April 30, 2018

**RE: SECOND DISAPPROVAL
SANITARY LAGOON INVESTIGATION
REVISED INTERIM MEASURES REPORT HYDROCARBON SEEP AREA
WESTERN REFINING SOUTHWEST INC., GALLUP REFINERY
EPA ID # NMD000333211
HWB-WRG-15-002**

Attachment A

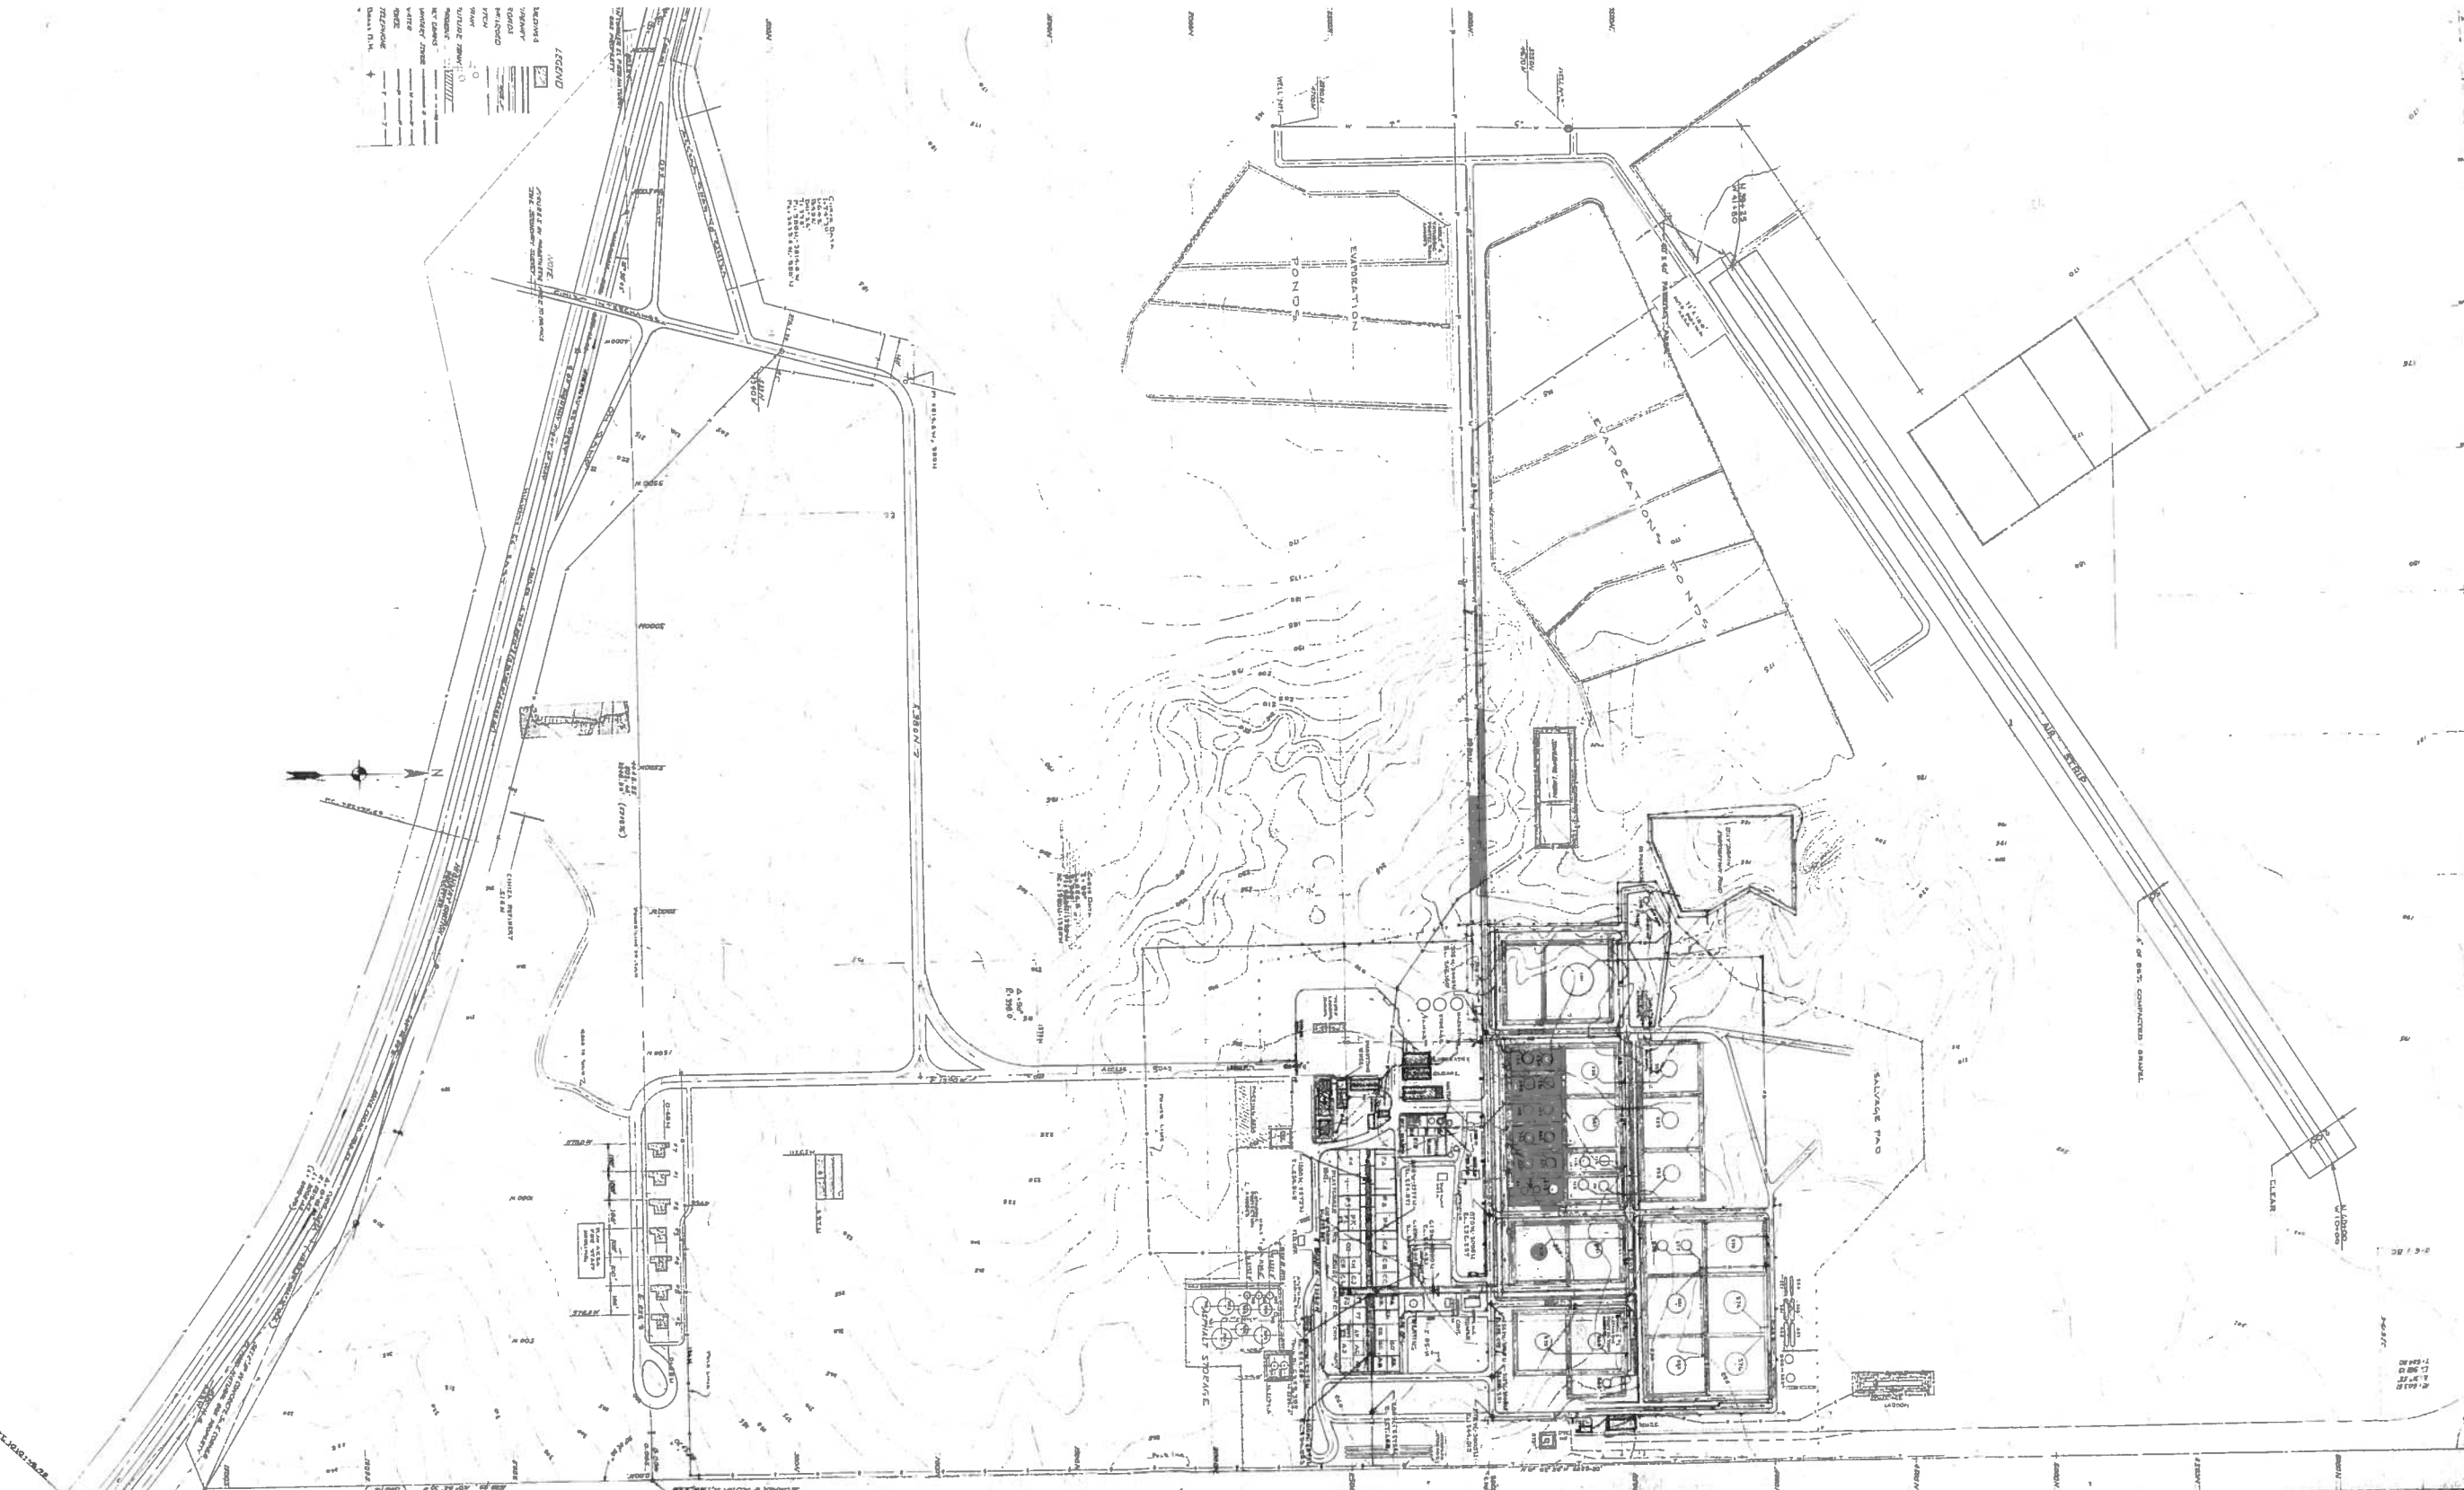
On the first page, second paragraph, the Permittee states, “[b]ased on sewer maps reviewed, it appears that the lab, change house, warehouse, and potentially the truck rack drivers lounge have sanitary sewer lines that discharge to the sanitary lagoon,” and “[y]es, sanitary effluent from the lab, change house, warehouse, and truck rack drivers lounge discharges to the area referred to as the sanitary lagoon.” In the dye test discussion dye testing for the warehouse was not mentioned. Please provide the information regarding dye testing for the warehouse.

Response: Attachment A and Attachment B are drawings that were evaluated for identification of possible sources of sanitary discharges to the sewage lagoon. A dye test at the warehouse bathroom was conducted on April 27, 2018.
